ADDENDUM NO. 2

RE: **ATHLETICS DEPARTMENT
University of Wisconsin – Whitewater
Whitewater, Wisconsin**

UWSA Project No.: **N-24-001**

UW-WHITWATER - MILLER
 STADIUM PRESSBOX
 University of Wisconsin-Whitewater
 Whitewater, WI
 Sheet Title:
 FLOOR PLANS - PRESSBOX

4 LEVEL 01 - REFLECTED CEILING PLAN
 1/4" = 1'-0"

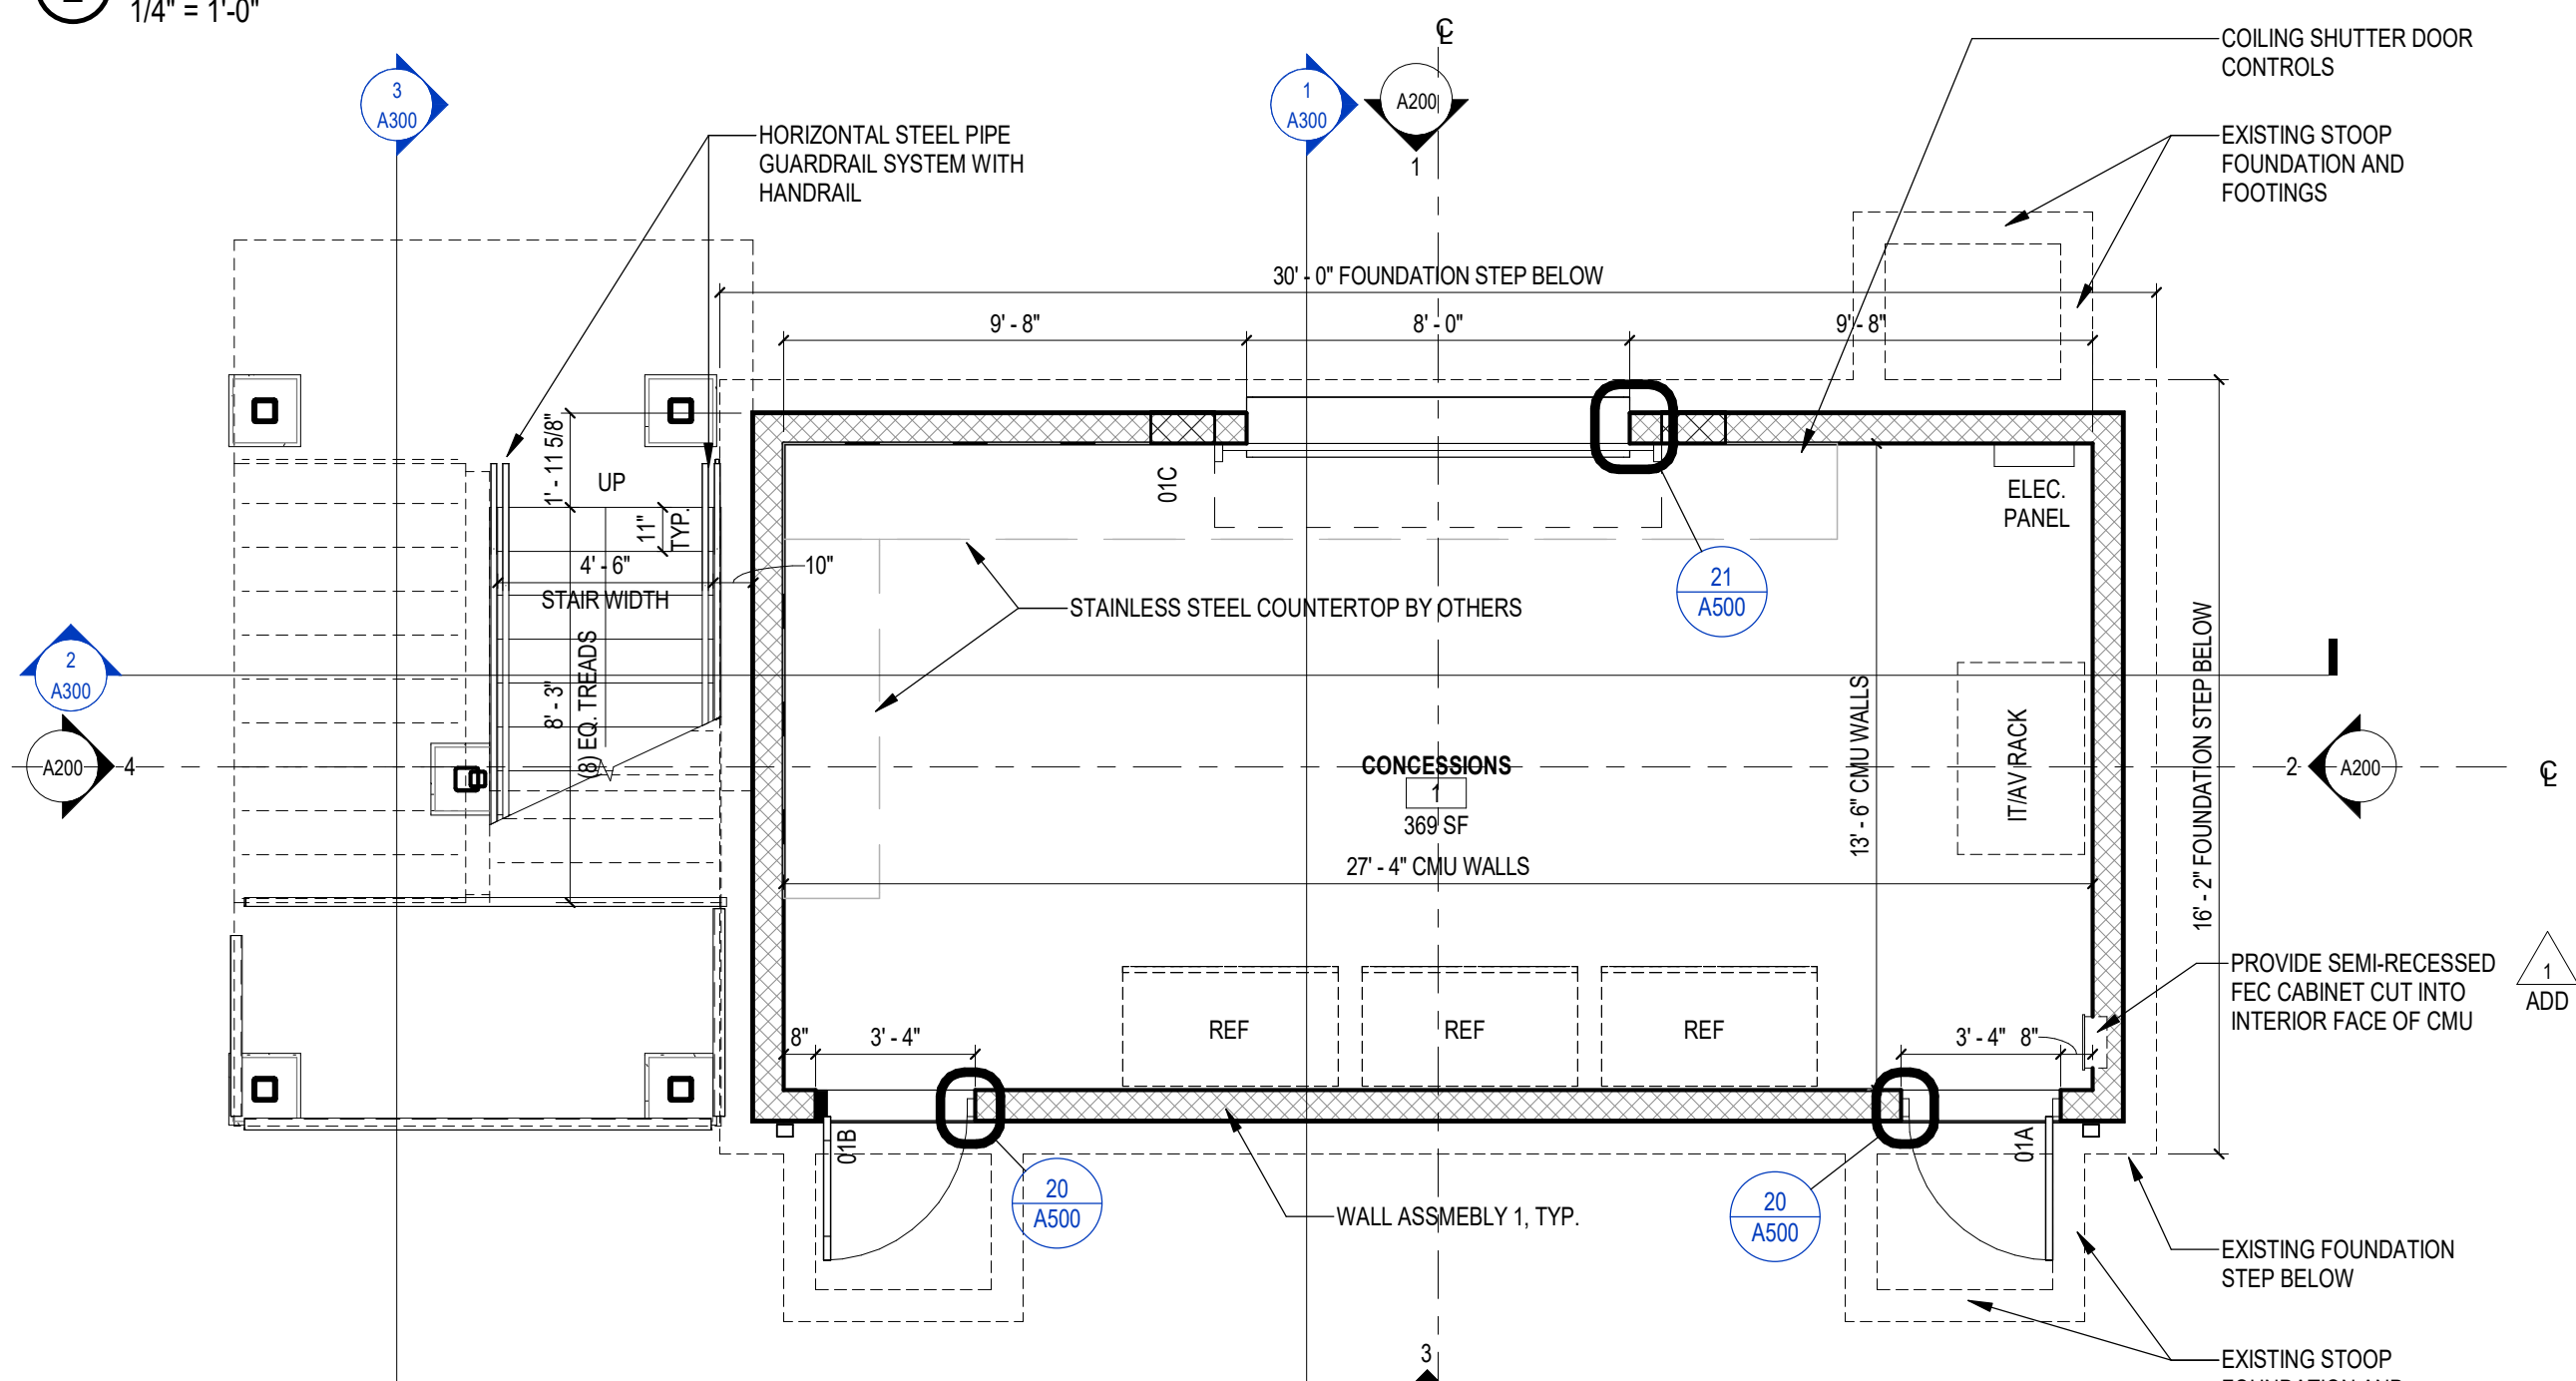
1. Sheet G002 – SPECIFICATIONS
 - a. Replace entire document with attached sheet G002
 - i. Section 08 33 13 – Overhead Counter Doors
 1. Removed lines J. and L.
 2. Revised section “N. Exterior Door Finish”.
 - ii. Section 08 71 00 – Door Hardware
 1. Added section “H. PRODUCTS”
2. Sheet A100 – FLOOR PLANS-PRESSBOX
 - a. Replace entire document with attached sheet A100
 - i. Added notes to door schedule.
3. Sheet A200 – EXTERIOR ELEVATIONS
 - a. Replace entire document with attached sheet A200
 - i. Revised glazing elevation dimensions and added notes.
4. Sheet A500 – DETAILS
 - a. Replace entire document with attached sheet A500
 - i. Revised framing size and insulation note 10/A500.
 - ii. Removed burnished block note 29/A500.
